PRODUCT UPDATE

Number: #164
 By: LEMO USA
 Date: May 26, 2016

1S Fixed Receptacle PCB Contact Length Change

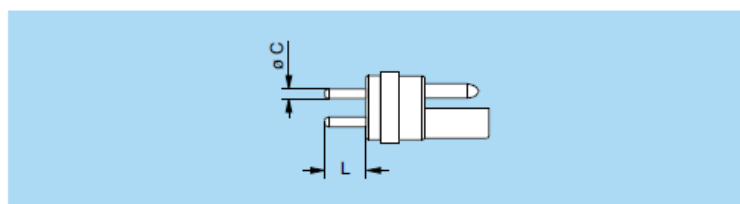
- PCB contact length change from 4.9mm to 3.0mm for 1S fixed receptacles with 3, 4 and 5 contacts.

- In order to standardize the PCB lengths throughout the models and maintain catalog accuracy the PCB contact length of the following items has been changed from 4.9mm to 3.0mm for the ERD.1S receptacles with 3, 4 and 5 contacts.
- Affected part numbers recently sold are **ERD.1S.303.CLN**, **ECP.1S.304.CLN** and **ECP.1S.305.CLN**
- If the longer 4.9mm length is still preferred it can still be ordered by adding a 'Y' to the suffix and reference this Product Update. For example: ECP.1S.304.CLN → **ECP.1S.304.CLN_Y**
